TSI 02/2021

Material change on our valve cover gasket 638.901 for
MAN D28

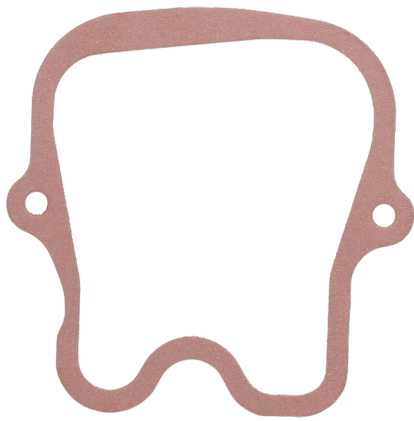
Old 638.901 – MAN 51.03905.0134
Material: EWP red (Soft material)

NEW 638.901 – MAN 51.03905.0134
Material: EWP 407 grey (Soft material)

We have improved our valve cover gasket 638.901 and replaced the coating with a completely new material development with the designation EWP 407. This material has a similar compressibility to the previous material, but now also has non-stick properties thanks to the PTFE coating. This makes disassembly easier and removes the cleaning required on the sealing surfaces almost completely. It has extremely good resistance to oils and fuels and also impresses with its excellent sealing performance even in unfavourable conditions on screw holes. The new material has also resulted in a visual change – the valve cover gasket is no longer supplied in the typical red, but now comes in grey and in the proven Elring OE quality.
